APPENDIX 6
Response to Comments Received by EPA Regarding the
Spruce No. 1 Mine 404(c) Determination

I. Response to Comments Received on the Spruce No. 1 Mine 404(c) Recommended Determination

Comments submitted by Hunton and Williams, counsel for Mingo Logan, on November 29, 2010, regarding EPA’s Recommended Determination.¹

FIGURE 3-15

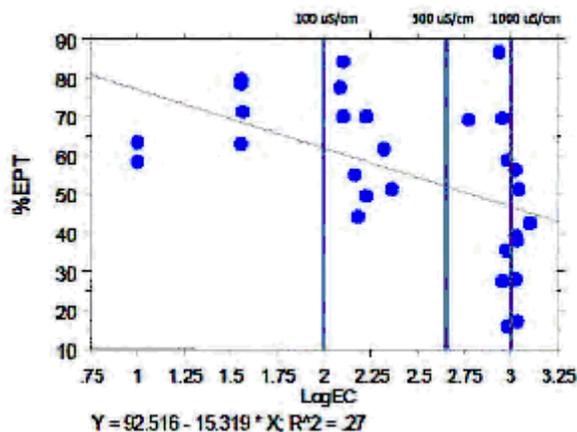
TED at 3.2.2 states that “Similarly, the results of an ongoing study of mined and unmined streams in the Spruce No. 1 Mine project area (the Dal-Tex study), clearly show that there is a poor correlation between EPT and EC, as seen in Figure 3-15.” “As these results show, conductivity accounts for only 27 percent of the variability in the percent EPT metric. This indicates that there are other variables that contribute to the widely scattered distribution of percent EPT, especially at the higher values approaching 1000 $\mu\text{S}/\text{cm}$, where there is a very wide distribution of the percent EPT results.”

EPA interprets the CH2M HILL data differently in that it is apparent that %EPT is not particularly sensitive to increased conductivity. Statistically speaking, Figure 3-15 appears to indicate a high degree of pseudoreplication (few individual points actually represent independent observations on independent streams); therefore these data violate assumptions of data independence and cannot be combined in this form to conduct a regression analysis. CH2M HILL's example using %EPT data from their Dal-Tex study streams clearly shows the ineffectiveness of this metric and EPA has documented in Appendix 2 of the Final Determination why this metric should not be used. To reiterate, communities from sites at the upper end of the conductivity scale in this graphic (CH2M HILL Figure 3-15) are obviously devoid of most sensitive native mayflies, stoneflies, and caddisflies and instead have likely been replaced by

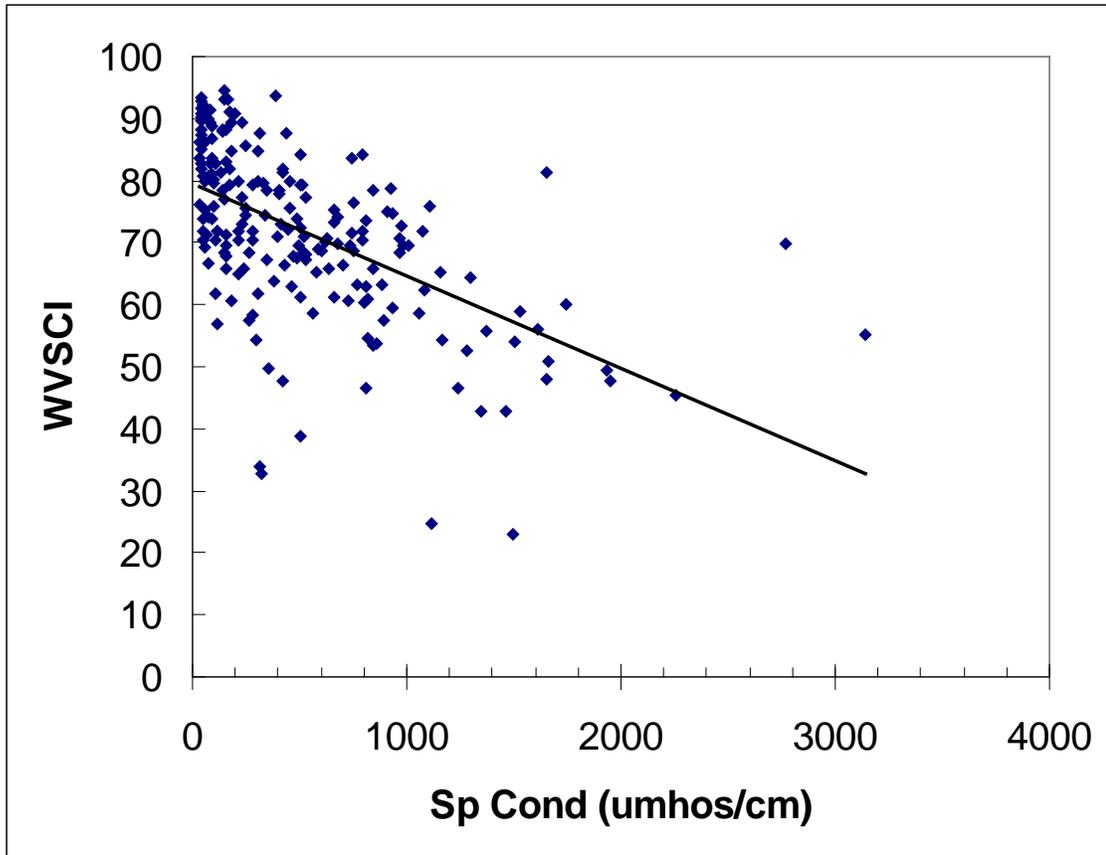
Comment #165A – West Virginia analyzed the use of conductivity and a change in EPT composition, and concluded that “EPA’s proposed limits are too narrowly focused on a single parameter and single aquatic species to determine the health of the impacted watershed.” “An ecosystem does not exist at a single point and, accordingly, its health cannot be assessed at a single point.”

Response #165A – See Responses #12, 66, 76, and 119A.

The WVDEP analysis of the 5505 sites does not partition natural variability in the dataset due to bioregion. The EPA analysis of WVDEP data considered only those sites in Ecoregion in 69d, where the proposed project is located, to help partition natural variability in water quality. Natural background conductivity in this region is very low: We estimate median conductivity of WVDEP regional reference sites in the Appalachian mountain region to be 49 $\mu\text{S}/\text{cm}$ (based on 128 sites (n=128)).

Plot of Conductivity-WVSCI Relationships Following Data Filtering

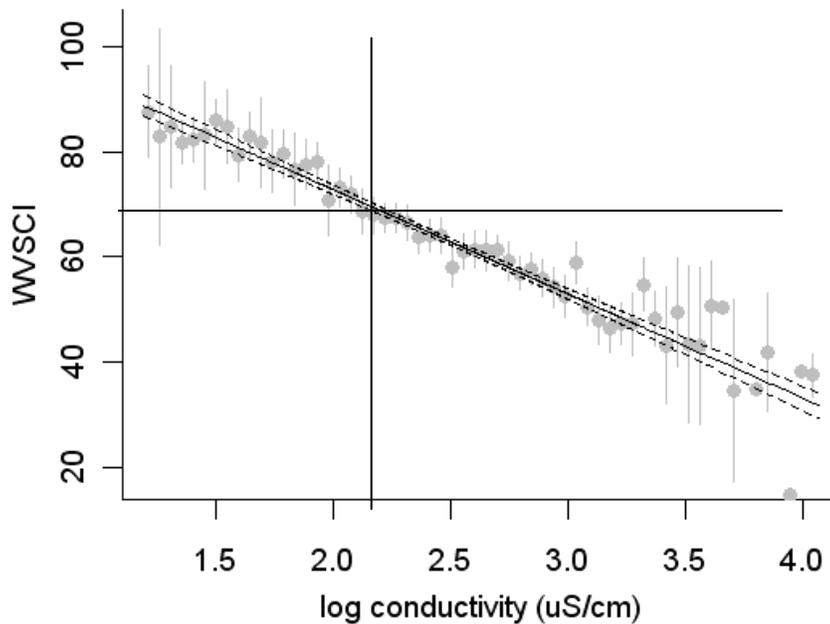
Comment #167A – Figure 1, which also appears in the WVDEP Justification document and is similar to one included in the initial CH2M HILL report (TED, Cmt. App.), makes clear that the “correlation” between conductivity and aquatic life use is tenuous at best.

Another technique of plotting WVSCI versus conductivity (log transformed) would be to plot the mean WVSCI score within individual bins of increasing conductivity. This technique focuses on the central tendencies of the data and diminishes the effect of outliers on the relationship. The means must be bound by confidence intervals to show the variation, but the relationship is better visualized than showing all samples. The graphic below shows WVSCI scores from the filtered dataset used in EPA's draft conductivity benchmark report (USEPA 2010a, graph provided by L. Yuan, EPA ORD). Here, WVSCI scores below 68, on average, are found when conductivity is greater than 250 $\mu\text{S/cm}$.

With respect to Figure 1 submitted by commenters, the scatterplot did not filter out poor habitat sites or low pH sites and does not account for other stressors. Where other stressors are filtered out, the correlation with conductivity is much stronger. See Response # 165A.

Figure showing close-up view of valley, sample location, and biological indices.

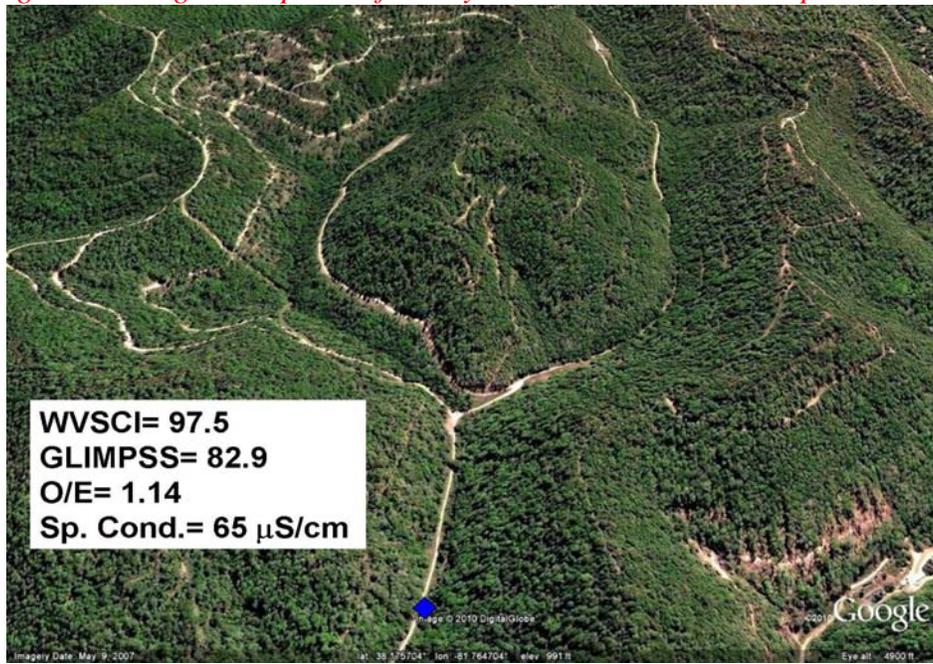
Comment #180A – Despite the importance of habitat, EPA did not adequately analyze habitat as a confounding variable. Instead, EPA’s O/E scores were based on sites with uniformly favorable habitat, and are therefore unreliably skewed. Only 5 of the 40 sites studied had habitat scores less than 140. Without a representative selection of habitat scores, EPA could not meaningfully assess the impact of habitat on EPT scores. This is a significant omission, since habitat is a better predictor of degradation, as measured by WVSCI scores.

The conductivity in Jimmy Fork was 65 $\mu\text{S}/\text{cm}$ and no mining or valley-filling had occurred in its headwaters. See figure below for aerial photos of Jimmy Fork.

Figure 6. Relationships between conductivity and macroinvertebrate metrics (Total Generic Richness, EPT Generic Richness, Ephemeroptera Generic Richness, and % Ephemeroptera Abundance) for mine site receiving streams located below in-stream impoundments (EPA data).

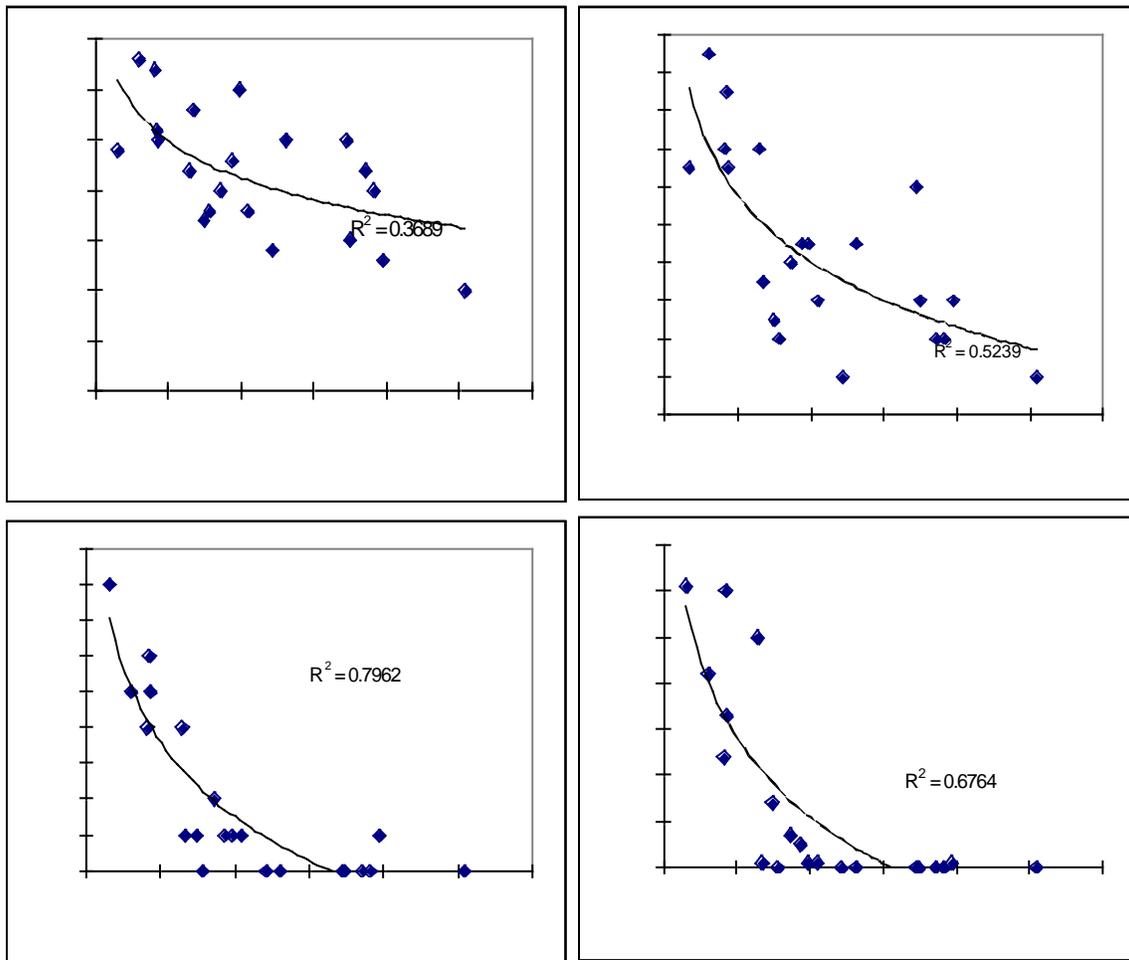
Comment #181A – In order to discount confounding factors, EPA primarily compared those factors to Ephemeroptera (mayflies), and excluded consideration of the rest of the macroinvertebrate community. To distinguish impoundment as a factor, for example, EPA relies on the correlation between Ephemeroptera and conductivity at impounded sites. This is inappropriate because the proposed correlation is between conductivity and all three Orders of EPT, not just Ephemeroptera.

Response #181A – See Responses #75 and 78. EPA disagrees. In its Final Determination analysis, EPA used EPT in the analysis of impoundments as a confounding factor. EPA did not solely rely on Ephemeroptera in this example (Appendix 1 of RD; Figure A6) and indeed confirmed that other metrics (total taxa richness and EPT richness) both significantly declined along a conductivity gradient below mined-only/ impounded-only sites. In the regression, conductivity explained 37% ($p < 0.001$) of the variance in total taxa and 52% ($p < 0.001$) of the variance with EPT richness. Prominently, 80% of the variance in Ephemeroptera richness was explained by conductivity at mined, impounded sites. This not only shows evidence that mayflies and other EPT are severely affected with increasing conductivity but indicates that when conductivity was relatively low (a situation that occurred at only 5 impounded mine sites), mayflies and other EPT were significantly more diverse and abundant, even below impoundments.

If the macroinvertebrate responses below valley fills were caused solely by the presence of upstream sediment ponds, the relationship between conductivity and macroinvertebrate metrics

Figure 2. Total Ephemeroptera Genera and Conductivity. TED2 § 3.2.2.

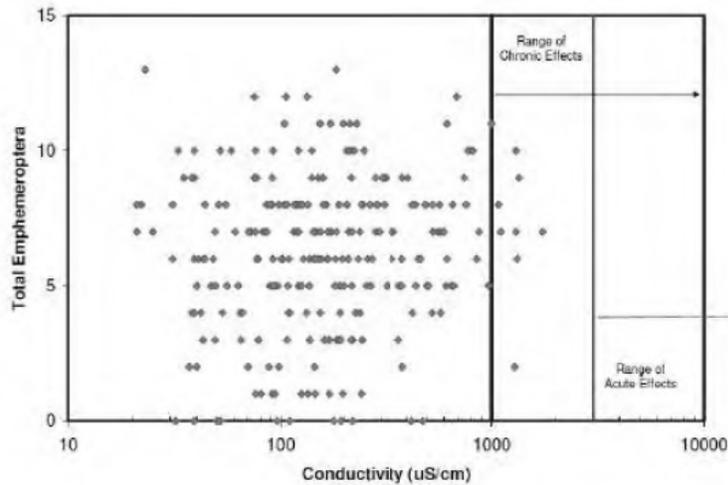
Comment #184A – And as commenters to the proposed conductivity limit have noted, there is no clear relationship between the number of Ephemeroptera genera and conductivity. Figure 2 shows the poor the correlation between Ephemeroptera and conductivity.

Response #184A – This comment references the draft EPA report, *A Field-Based Aquatic Life Benchmark for Conductivity in Central Appalachian Streams* USEPA 2010a). EPA’s Section 404(c) Final Determination and its discussion of conductivity, which includes a dose-response model to predict conductivity levels, are not based on this conductivity benchmark value. EPA references this report and the draft conclusions of EPA’s Science Advisory Board within the Final Determination and these responses to comments as confirming evidence of the strong relationship between surface coal mining, elevated levels of total dissolved solids (conductivity), and impacts to macroinvertebrate wildlife. EPA notes that the report is undergoing independent peer review. We also note that the Science Advisory Board’s draft review comments are supportive of EPA’s field-based benchmark derivation methodology and note that the review panel emphasizes that there is “clear evidence that valley fills are associated with increased levels of dissolved ions (measured as conductivity) in downstream waters, and that these increased levels of conductivity are associated with changes in the composition of stream biological communities” (SAB 2010).

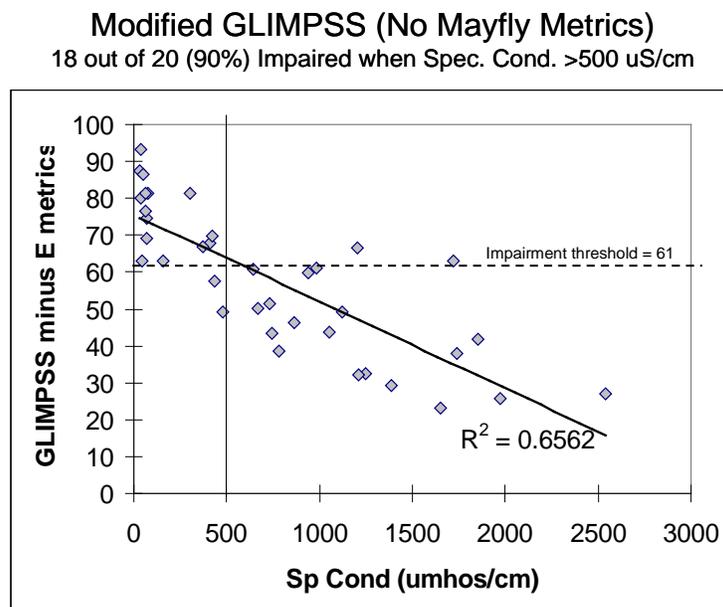
Comment #73 - There are other possible reasons for differences in macroinvertebrate indices between affected sites and sites not attributable to pollutants or pollution, including hydrological modification effects and changes in food resources below impoundments.

Response #73 - See Response #78.
